Access Compliance Report Public Rights-of-Way (Curb Ramps)

Main Street: MARCY_RANCH_RD Cross Street: MARCY_DR Location: NE

ADA ID: RPRK211012173650 Ramp Type: Type 1 - Perpendicular Diagonal Initial Pass/Fail: Pass Overall Compliance: No Severity Score: 9

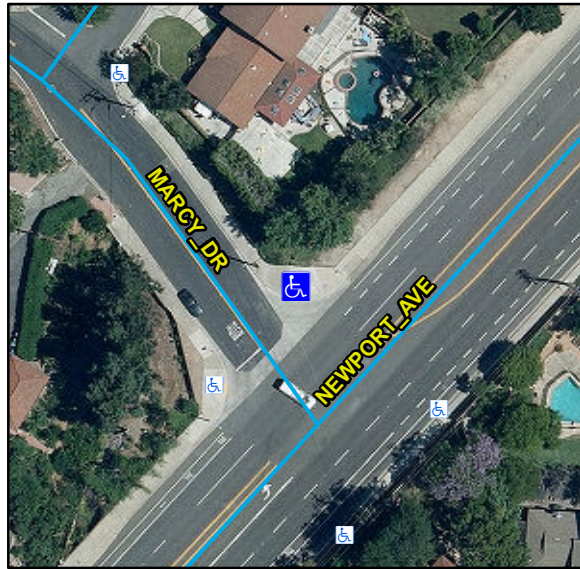
Compliance	Description	Data	Compliance	Description	Data
N/A	Ramp Length (in)	130	N/A	Flare Type LT	
Yes	Ramp Width (in)	48			Sloped
Yes	Ramp Run Slope (%)	6.4	Yes	Flare Slope LT (%)	6.8
Yes	Ramp Cross Slope (%)	1.1	N/A	Flare Traversable LT	Yes
N/A	Landing Present	Yes	N/A	Flare Type RT	
N/A	Landing Length (in)	47			Sloped
Yes	Landing Width (in)	48	Yes	Flare Slope RT (%)	4.2
Yes	Landing Run Slope (%)	1.2	N/A	Flare Traversable RT	Yes
Yes	Landing Cross Slope (%)	0.4	Yes	DWS Provided	Yes
N/A	Landing Movement Obstructed?	No	Yes	DWS Contrast	Yes
	Landing Movement Type	N/A	Yes	DWS Length (in)	36
N/A	Landing Shared	No	Yes	DWS Full Width	Yes
N/A	Clear Space	Yes	Yes	DWS Offset Left (in)	0
N/A	Clear Space To Crosswalk (in)	48	Yes	DWS Offset Right (in)	N/A
N/A	Marked Crosswalk 1	No	N/A	Marked Crosswalk 2	No
	Crossing 1 Direction	W		Crossing 2 Direction	S
	Marked Crosswalk 1 Width (in)	N/A		Marked Crosswalk 2 Width (in)	N/A

N/A	Ramp Inside Crosswalk 1	N/A	Yes	Ramp Inside Crosswalk 2	N/A
	Crossing 1 Slope (%)	5.7		Crossing 2 Slope (%)	8.1
	Crossing 1 Cross Slope (%)	2.4		Crossing 2 Cross Slope (%)	0.9
Yes	Gutter Ponding	No	No	Curb Slope	10.4
Yes	Gutter Lip Height (in)	0		Road Run Slope (%)	3.6
No	Gutter Run Slope (%)	5.8		Road Cross Slope (%)	3.5
Yes	Gutter Cross Slope (%)	1.2			
Yes	Overall Surface Condition: Acceptable		Yes	Perp Joint Present	Yes
	Cross Gutter Present?	Yes		Spandrel Present?	Yes
	Replace Cross Gutter?	No		Replace Spandrel?	No

Remove & Replace Curb Ramp With Two New Directional Ramps or Equivalent. Remove & Replace Gutter.
